GEORGETOWN UNIVERSITY TOWNHOUSE EXTERIOR REPAIRS

OLD GEORGETOWN BOARD SUBMISSION - JANUARY 2023

Re: Response to Comments: Project Address:3609 O St. NW

VA2205-04 3609 O St.

AP1

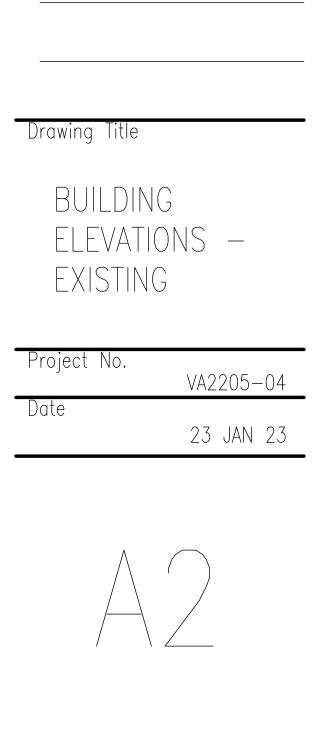
5. Why is a window on AP1 marked for roof demolition? Does this note refer to coping or is it a typo?

Mark deleted from photo.

AP3

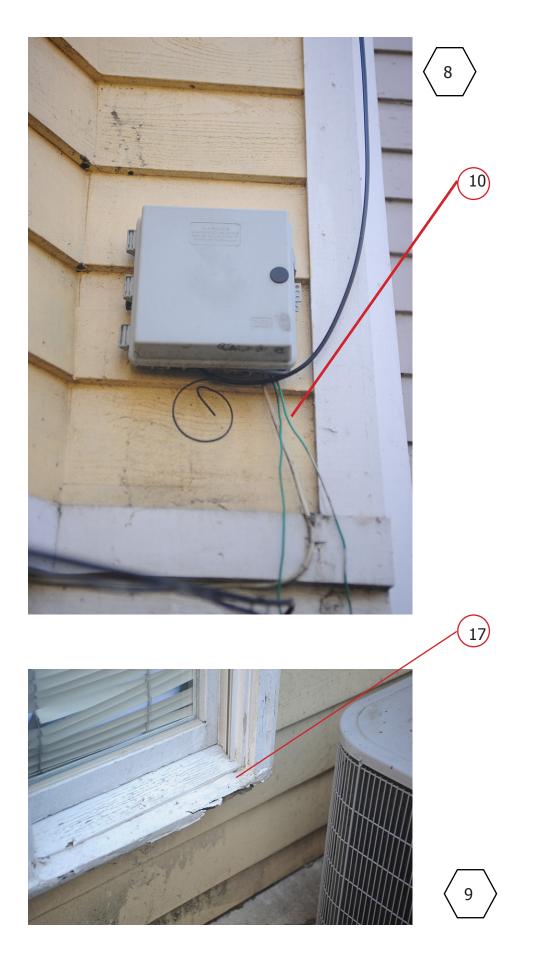
3. The notes on photographs indicate the alley door is to be repaired whereas the drawings say it will be replaced. Please revise for consistent specs. The replacement door should be wood.

Alley door is be repaired. Drawings will be updated to reflect this. A4/AP3
